**TOWN OF NEWBURGH
PLANNING BOARD
TECHNICAL REVIEW COMMENTS**

PROJECT NAME: VANTAGE CONSTRUCTION
PROJECT NO.: 23-03
PROJECT LOCATION: KINGS HILL ROAD
SECTION 11, BLOCK 1, LOT 66.21
REVIEW DATE: 9 JUNE 2023
MEETING DATE: 15 JUNE 2023
PROJECT REPRESENTATIVE: NOSEK ENGINEERING/ACES SURVEYING

Re: Vantage Construction 4-Lot Subdivision
Kings Hill Road
Town of Newburgh, Orange County, N.Y.

PROPOSED DRIVEWAY SIGHT DISTANCES:
Lot #3&4 common: left 380' - right 300'

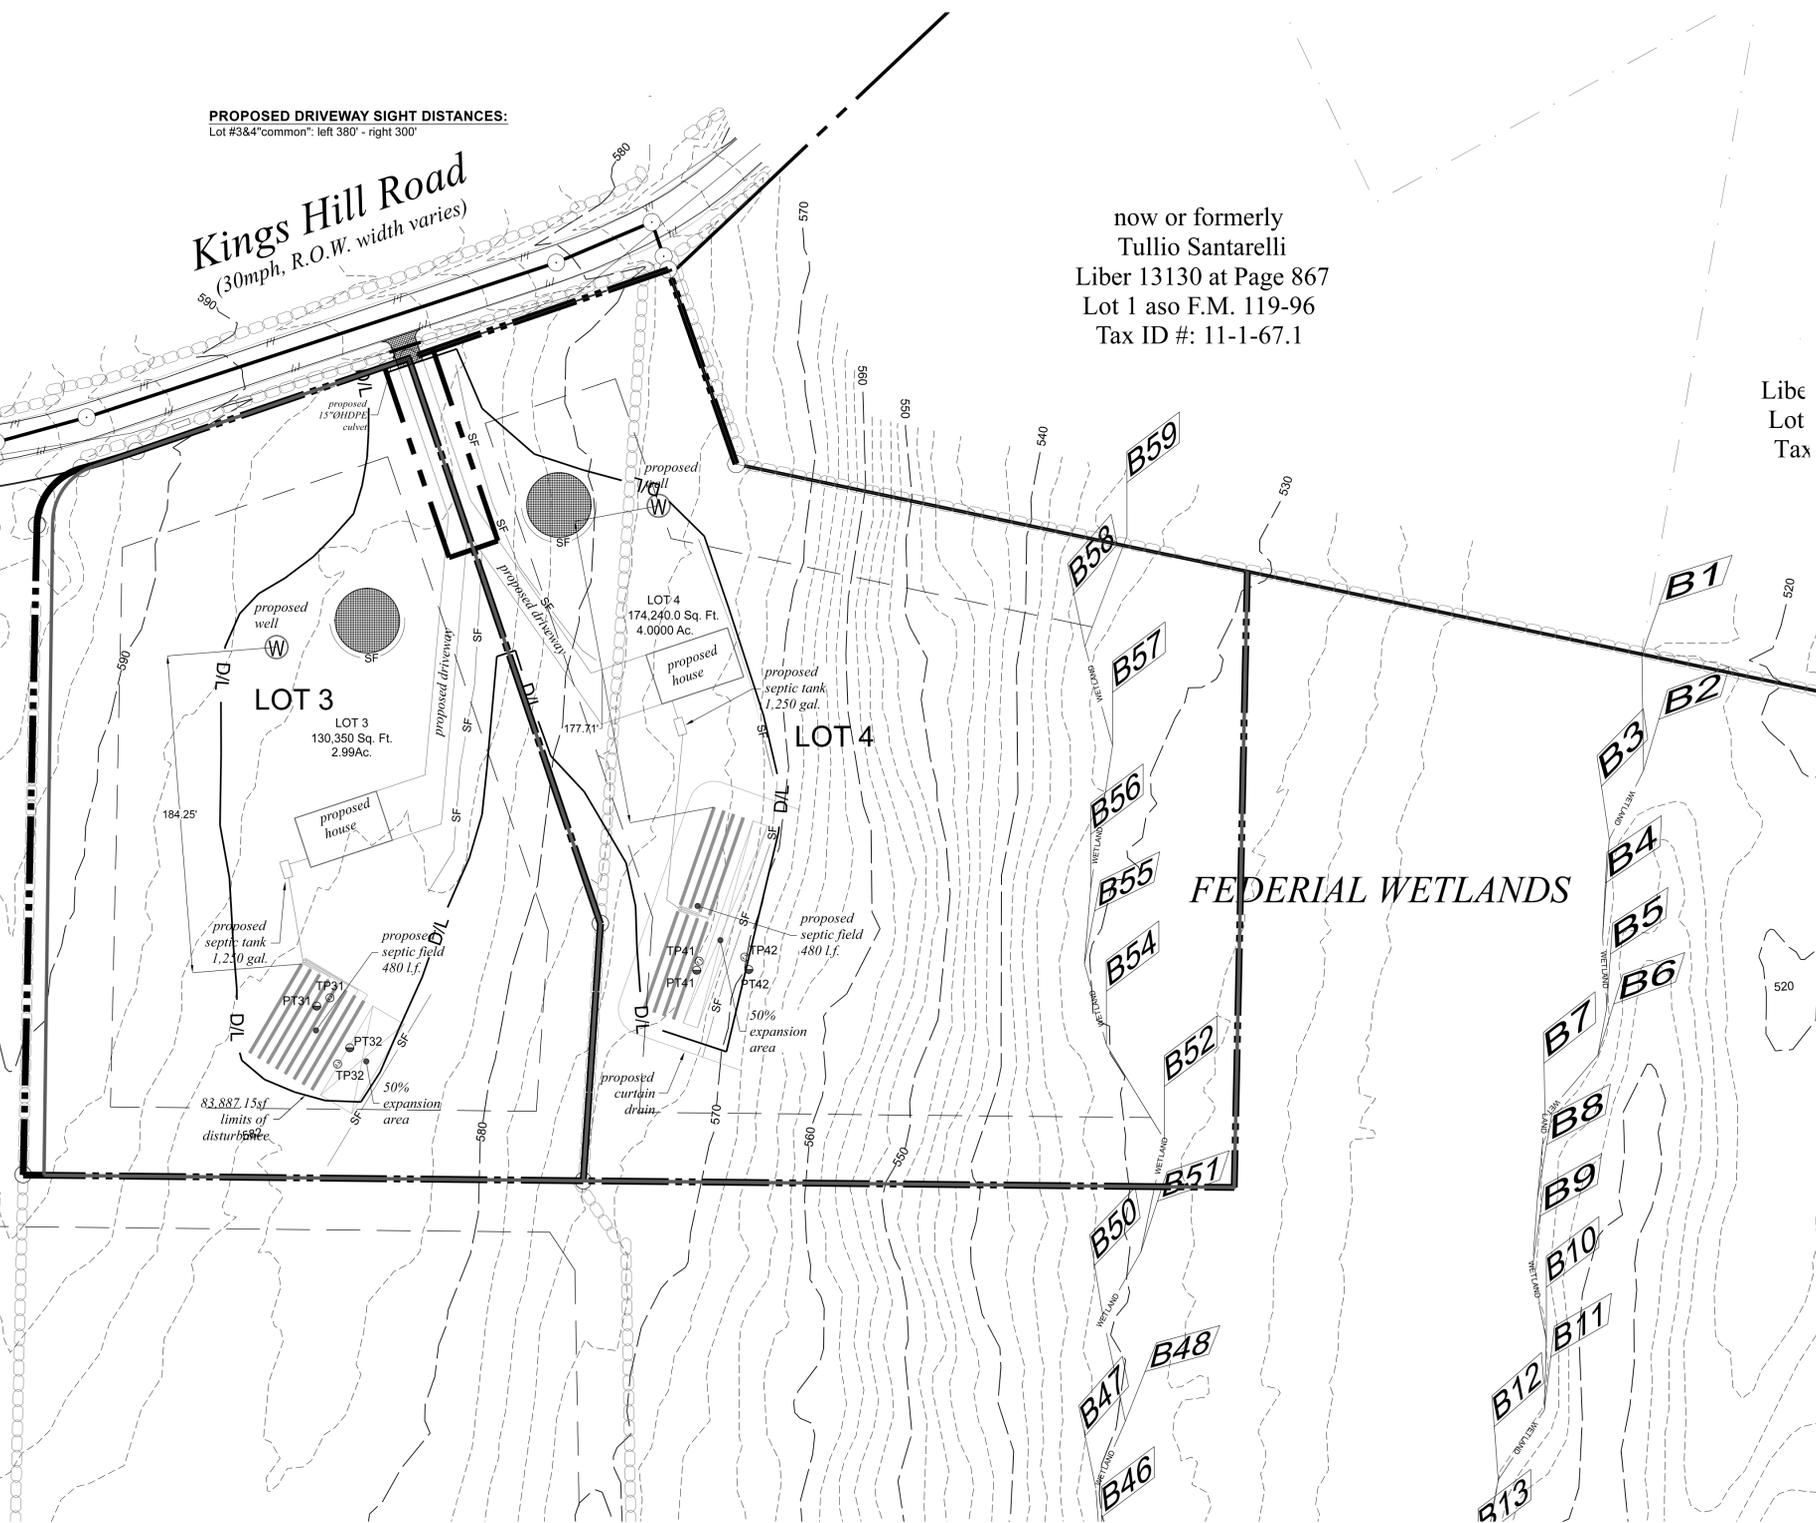
2. A Common Driveway Access & Maintenance Agreement will be required for Lots 3 & 4 (potentially Lots 1 &2).
3. The project will require coverage under the NYSDEC Stormwater Construction SPDES Permit. This will be required prior to stamping of the subdivision plans.

8. A common driveway easement is now shown on the plans for lots 3 and 4. A maintenance agreement will be provided and executed as a condition of approval.

PROPOSED DRIVEWAY SIGHT DISTANCES:
 Lot #1: left 500' - right 500'
 Lot #2: left 350' - right 360'

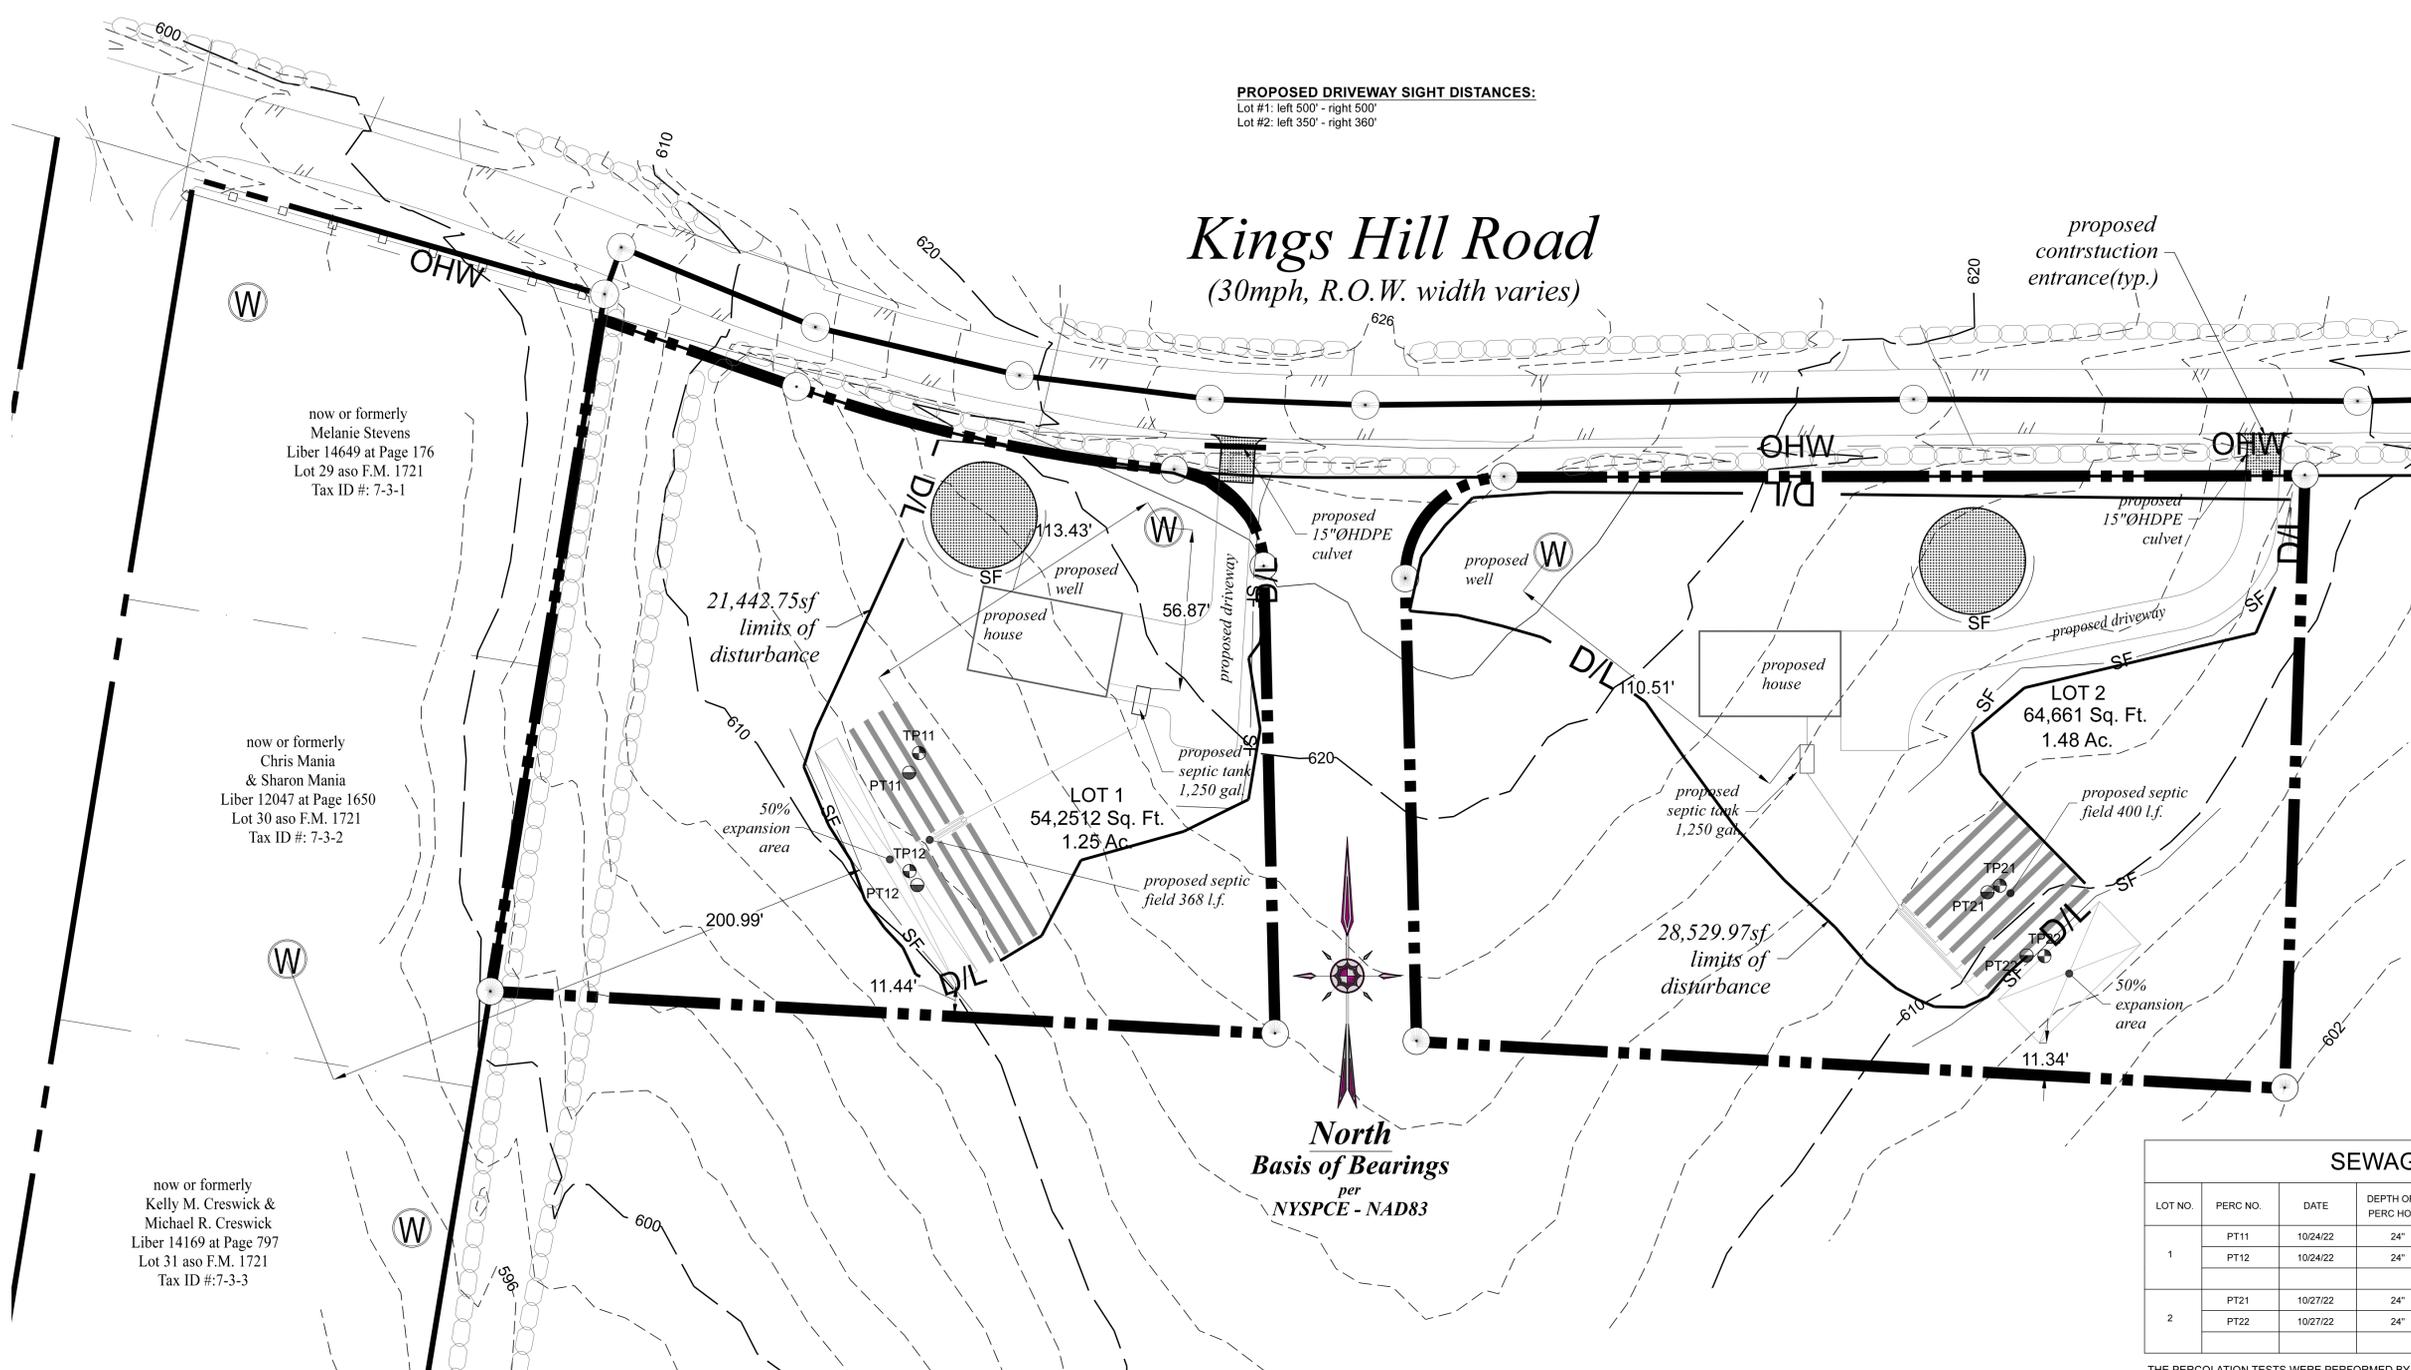
1. The applicant's representatives are ask to consider relocating the proposed driveways for Lot 1 & 2 to the 50-foot wide access strip between the lots which is apparently proposed to provide future access. Common driveway constructed within the 50-foot strip would then permit the driveways to access from any future roadway. It is noted the proposed driveway for Lot 1 crosses a piece of the 50-foot Right-of-Way currently depicted and would require and easement.

3. Sight distances have been shown for each driveway. The driveway on lots 1 and 2 had to be shifted to provide better sight distance.
4. General note 19 has been revised.

Simple SWPPP Plan
for
Vantage Construction

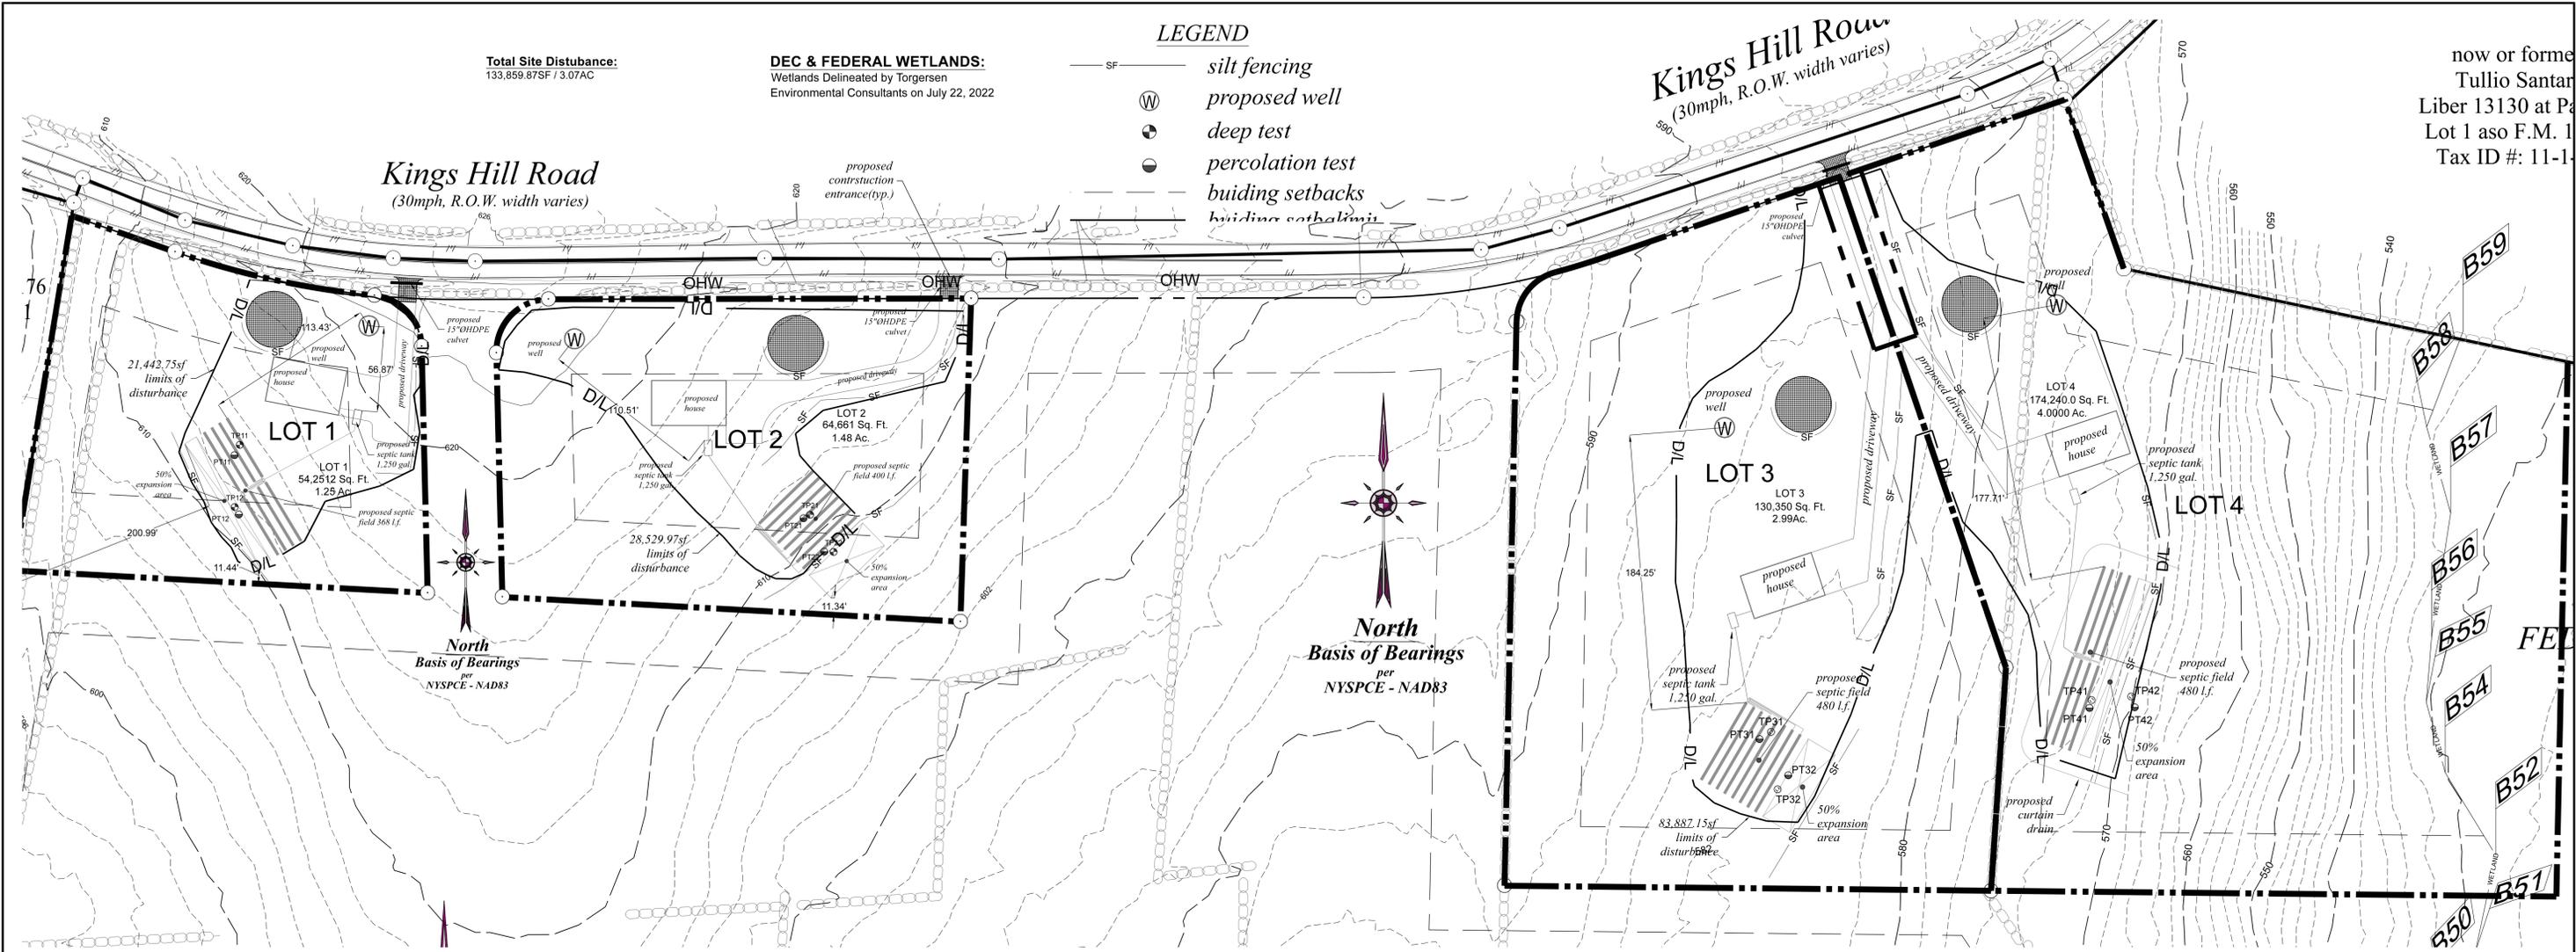
4. Driveway locations must be approved by the Highway Superintendent.
5. Tree Preservation Plan was not received.
6. The SWPPP plan is labeled 1 of 6 as is the survey sheet for the entire parcel.

9. A Simple SWPPP is required for this project as the total area of disturbance is 3.07 acres. This plan is included as sheet 6. An eNOI will be prepared and NYSDEC Construction SPDES permit obtained prior to the start of construction on any lot.
10. Sheet 6 now includes a Tree Location Survey as required by the Town ordinance. It shows all trees with numbering, size and type of tree which meets the minimum requirements of the tree ordinance.
11. So noted.
12. Adjoiner notices have been sent out.
